# **Geotechnical Investigation Proposed Commercial Development**

480 & 486 Citigate Drive  
Ottawa, Ontario

Report PG6514-1 Revision 2 dated October 10, 2023

**re:** **Geotechnical Response to City Comments**  
**Proposed Commercial Development**  
480 & 486 Citigate Drive – Ottawa, Ontario

Title: **TEST HOLE LOCATION PLAN**

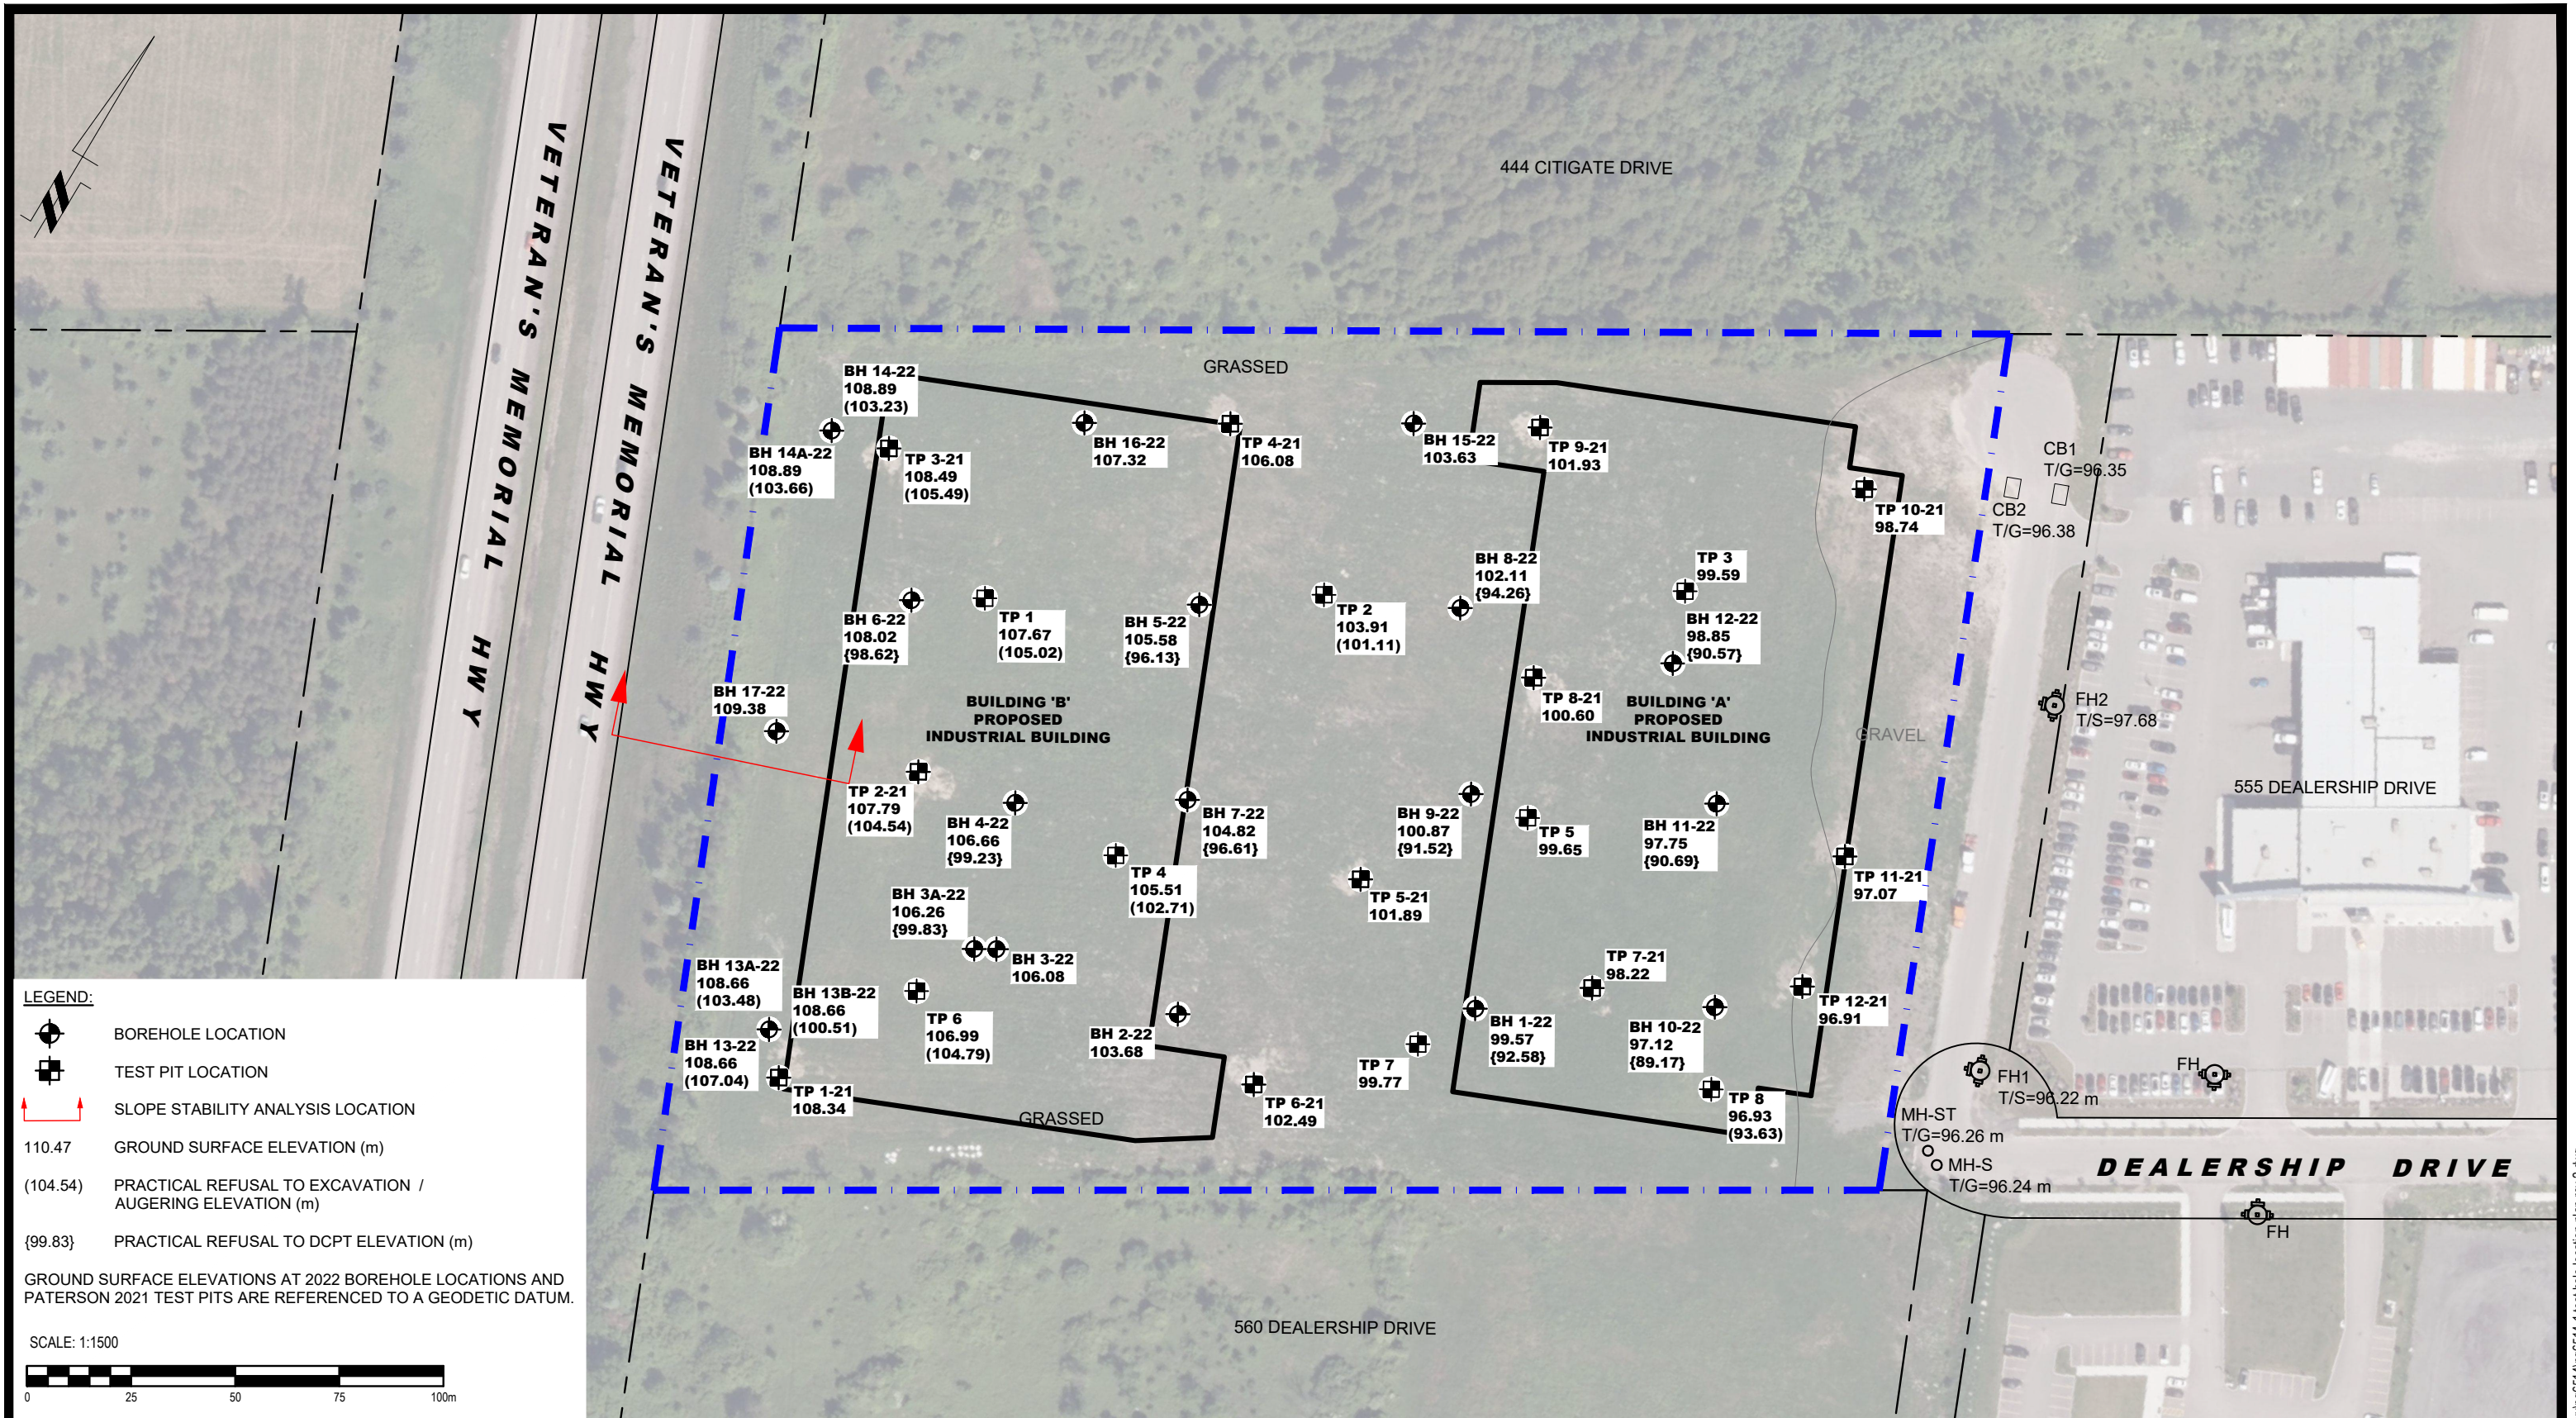
**Comment B2:** *Section 5.1 – Geotechnical Assessment: Provide a schematic and identify where the grade raise restriction is applicable.*

**Response:** Paterson prepared a permissible grade raise (PGR) plan for the subject site to identify the areas where a PGR restriction will be applicable. Reference should be made to Drawing PG6514-2 – Permissible Grade Raise Plan attached to Paterson Group Report PG6514-1 Revision 2 dated October 10, 2023, for the grade raise restriction recommendations plan.
